| | / / / |
|---|--|
| APPLICATION NO: | 14/00162/FUL |
| LOCATION: | Former Dawsons Dance Centre, Lunts Heath Road, |
| PROPOSAL: | Proposed residential development of 13 no. detached |
| RECOMMENDATION: | Approval |

Figure 1: Overlay of previous scheme.

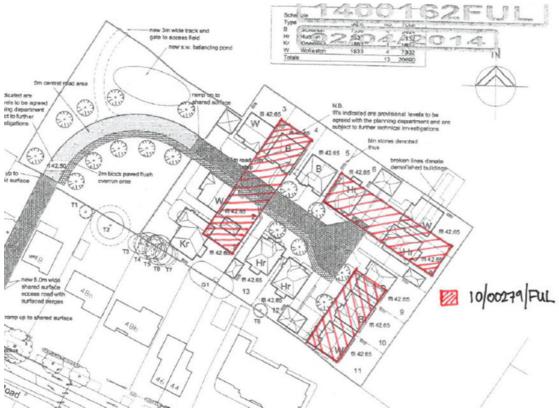
With regards to views in and out of the site and the potential impact of the openness of the Green Belt, the built form would be slightly spread out compared to the previously approved scheme as can be seen in figure 1 below.

However, the previous scheme was made up of a mews style of development, consisting of three blocks around a court yard. The current scheme provides for separation between the dwellings, and therefore potential views across the site that did not exist previously. For these reasons, and in light of the previous approval, it would be difficult to uphold an objection on impact on the Green Belt.
